CAPRICORN MUNICIPAL DEVELOPMENT GUIDELINES

2023 MEETING 1 MINUTES

Date and Time: 3rd February 2023 at 11:00 am

D05.18. PIPE MATERIAL

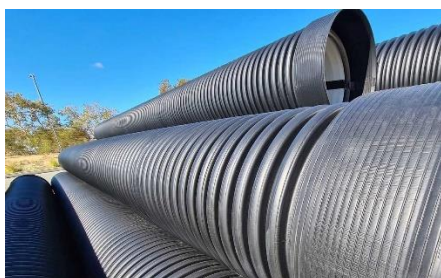
- C221 Section C221.04 mentions FRC and RCP pipes but not Plastic.
- Current Section D05.18 reads as follows.

- It is noted that Hydra Storm supplies pipe as follows:
 - Manufactured in accordance to AS – NZS 5065
 - Available from Diameter Nominal (DN) 225mm to 600mm
 - Manufactured from recycled HDPE

- C221 will need to be updated at the same time as D5.
- Richard mentioned that he is meeting with a representative from Iplex next week where he will get additional information and specifications.

Update D5 and C221 to permit polypropylene pipes (SN8) in urban areas only up to 600mm diameter. Add notes around to be installed as per manufacturers specifications. Revised documents to be sent to committee for review.

D12 – Polypropylene maintenance structures for gravity sewers – No resolution this meeting

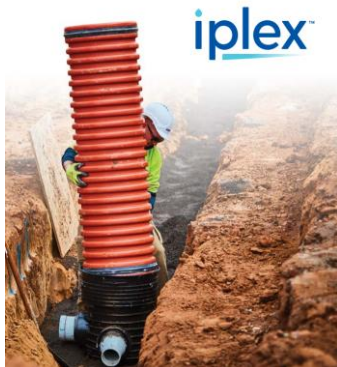
- Iplex has requested that CMDG D12 be updated to allow for the use of 1000mm dia polypropylene maintenance shafts.
- The Iplex Ezipit technical guide is included as **Attachment S**
- EZI pit, in all the sizes (MS (DN425), MC(DN600) and MH(DN1000)) are approved by the majority of the water Authorities in Melbourne, approved by Unity Water, Gold Coast Council, Logan Council, and Redlands Council in the SEQ water grid.
- The EZIpit has been around for a number of years - with about 15 years of use in Australia and 35 years use in Europe.

- Some discussion and revisiting of LGA preferences for maintenance shafts in CMDG
- Some feedback that internal ribbing could hold up debris

- Isaac regional Council accept the use of the polypropylene chambers as access chambers. New table of difference to be added to D12 for use of 1000 dia polypropylene access chambers as an alternative to concrete access chambers.
- LSC and CHRC to confirm the use of the polypropylene structures for maintenance shafts only (ie 600 diameter)
- LSC to provide an update about approval in table D12.09.04
- MCE to send update email to Iplex once above items have been confirmed.

PLAN – WIDE FOOTPATHS
SCALE 1 : 40

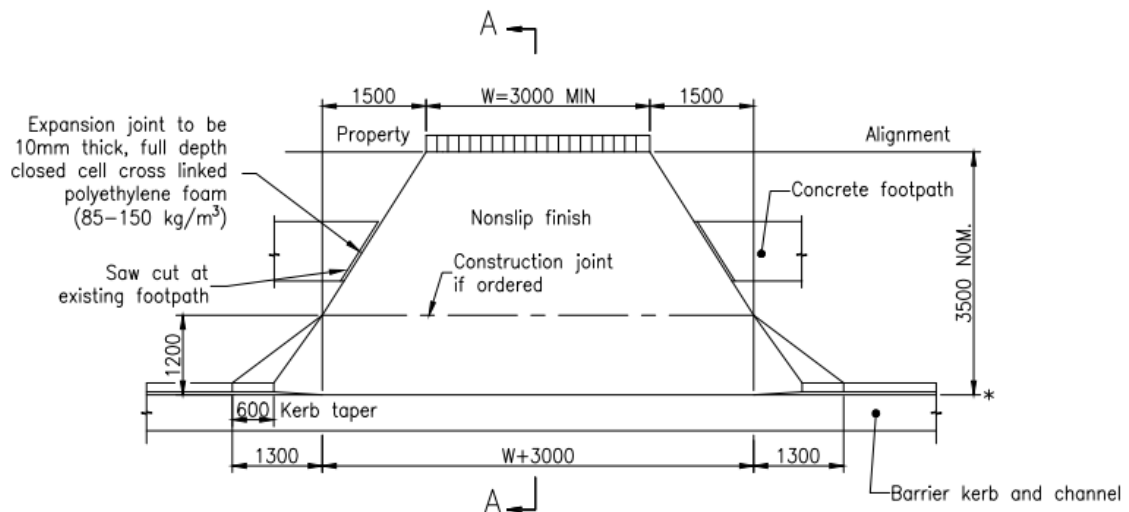
It has been pointed out that the kerb taper shown in the plan view is drawn incorrectly

Update drawing and send to committee for review.

Standard Drawing W-090 - 20 & 25mm Service and Water Meter Connections – No resolution this meeting

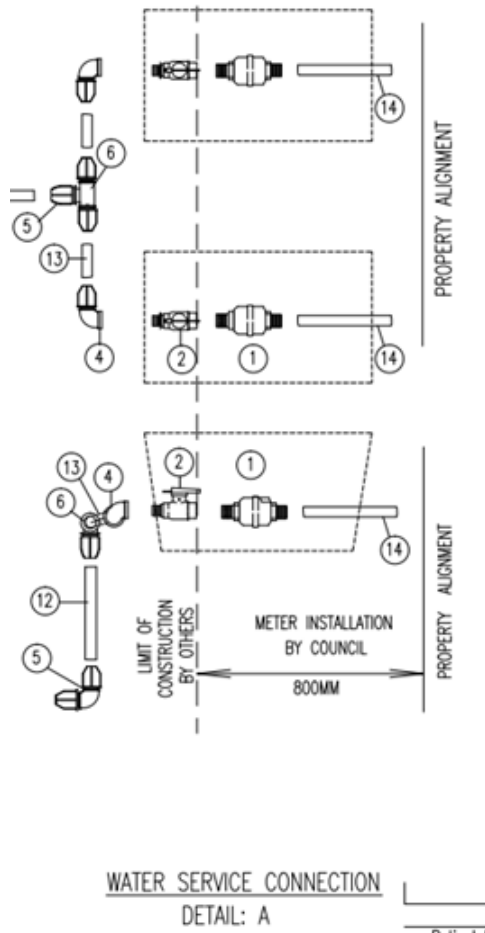
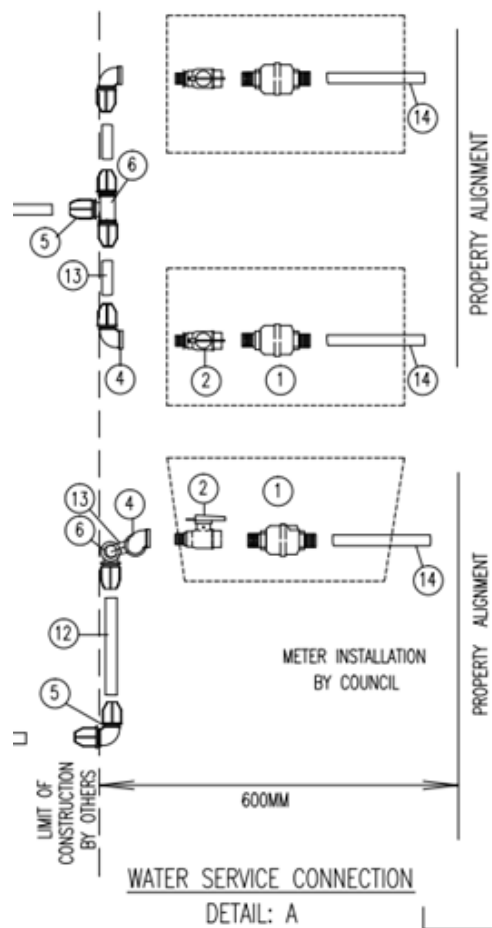
The key difference between the drawings W-090 and W-090A is the water service connection detail:

The other difference between the drawings is just the short single size on the W-090A is 25mm not 32mm, this could be covered in the applicability table if required.

The main benefit from not installing the valve is reduction in the risk of water theft.
